## LUFTDYKTIGHETSPÅBUD (LDP)

CESSNA - 1

### 96-086 KONTROLL/UTSKIFTING AV «ENGINE OIL ADAPTER»

**96-12-22 CESSNA AIRCRAFT COMPANY:** Amendment 39-9665; Docket No. 93-CE-54-AD.

Figure 1 Oil Filter Adapter Installation

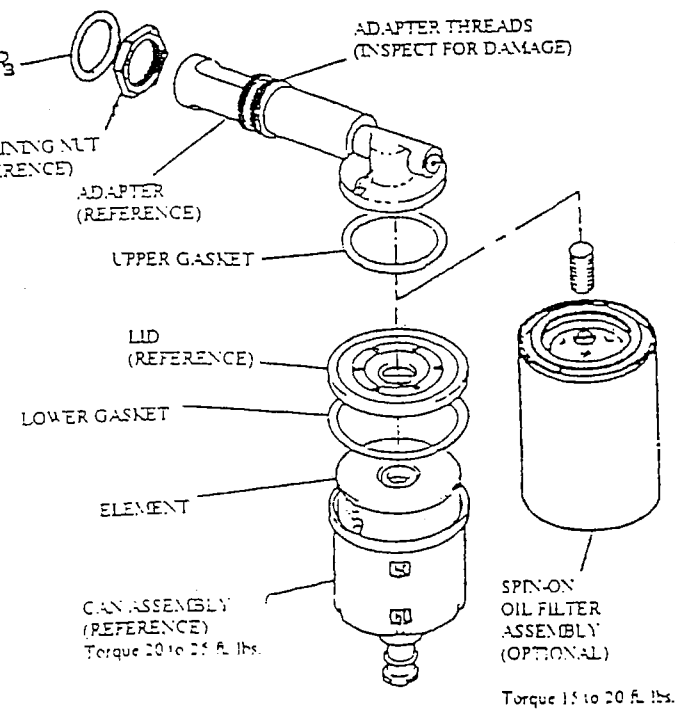
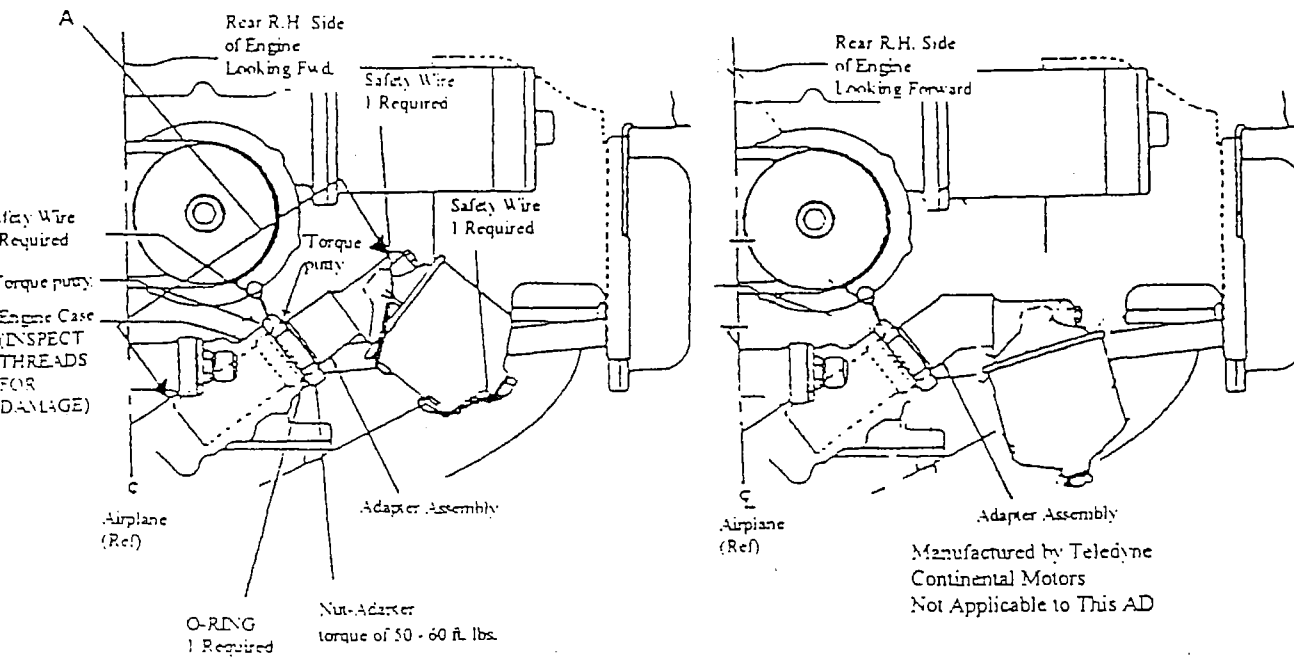
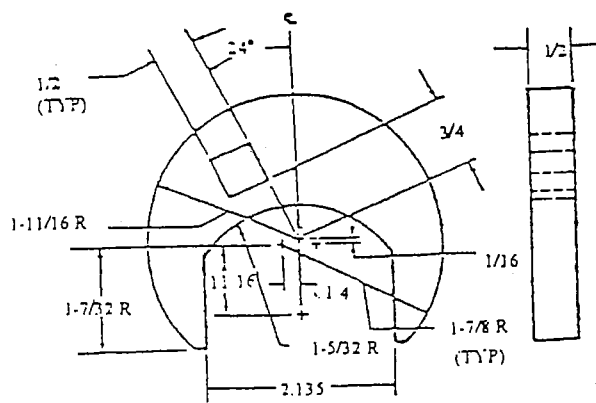
NOTE 2: This AD does not apply to engine oil filter adapter assemblies manufactured by Teledyne Continental Motors (See Figure 1 of this AD).

(4) Apply torque putty between the engine filter adapter assembly, nut, and oil pump housing as specified in Figure 1 of this AD.
